Figure IWB-2500-7(a)
Nozzle in Shell or Head
(Examination Zones in Barrel Type Nozzles Joined by Full Penetration Corner Welds)

PROPOSED CODE

IWB-2500-7(c)
Nozzle in Shell or Head
(Examination Zones in Set-On Type Nozzles Joined by Full Penetration Corner Welds)

Editorial
Change

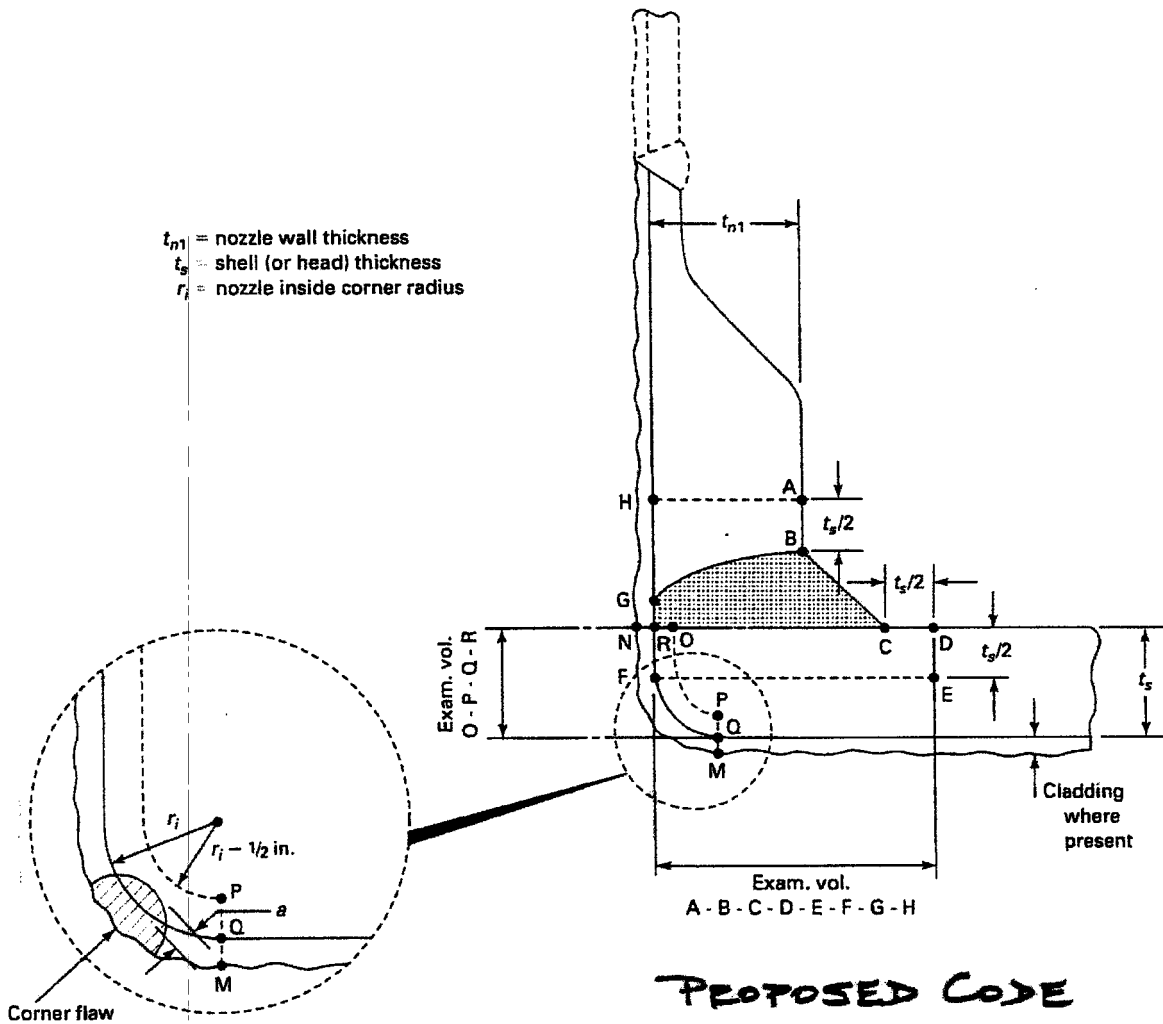
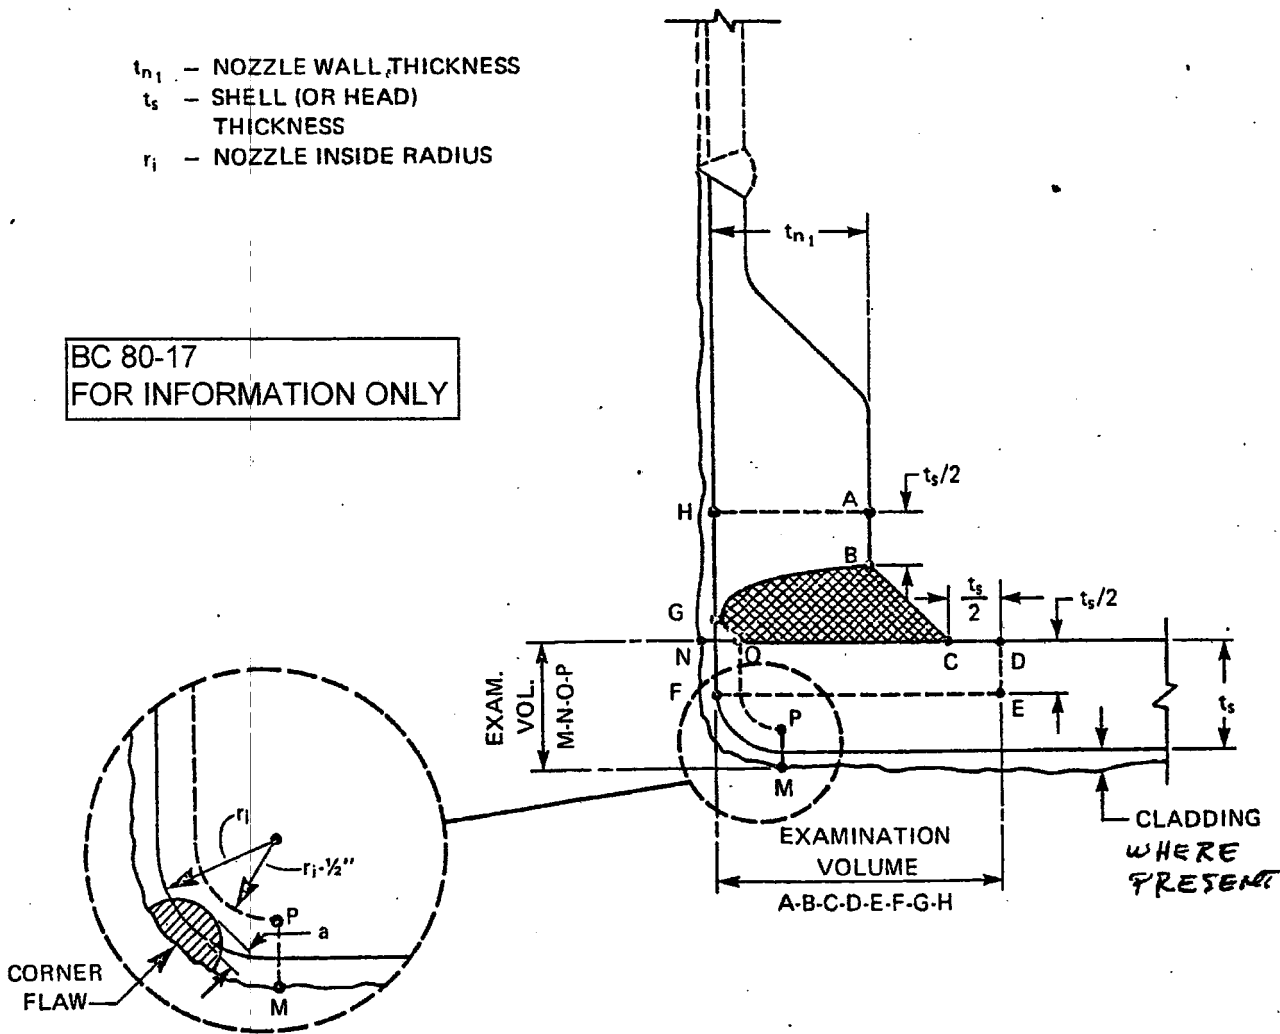
C-D-E-F-G ← **C-D-E-F-R**
 B-C-G ← **B-C-R**
 A-B-G-H
 O-P-Q-R
BCRG
